**Object: Aptiv external communication about Product and/or Process evolution**

**Male Terminal RCS800 Plastic Cap capacity increase**

<b>Change description</b>	<p><b>Object :</b></p> <p style="color: blue; font-size: 1.1em;"><b>Our supplier BAUD (France) is increasing Plastic Cap capacity with a new 8 cavities Mold.</b></p> <div style="text-align: center; margin-top: 20px;">  </div>		
	<p><b>Reason:</b></p> <ul style="list-style-type: none"> <li><input type="checkbox"/> Quality improvement</li> <li><input type="checkbox"/> Technical product/process improvement</li> <li><input type="checkbox"/> Restart of production after one year stop</li> <li><input type="checkbox"/> Manufacturing location transfer</li> <li><input type="checkbox"/> Bill of matériel updating</li> </ul>	<ul style="list-style-type: none"> <li><input type="checkbox"/> Cost reduction</li> <li><input type="checkbox"/> Product version creation/suppression</li> <li><input checked="" type="checkbox"/> Capacity increase</li> <li><input type="checkbox"/> Documents updating</li> <li><input type="checkbox"/> Other</li> </ul>

Plastic CAP design overview

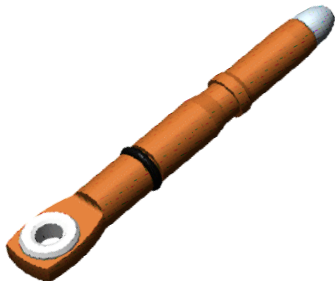
- Product at BAUD (Fance)  
Mold 8502 D 4  
8 Cavities

Slight visual aspect without functional impact (Test report 351889)
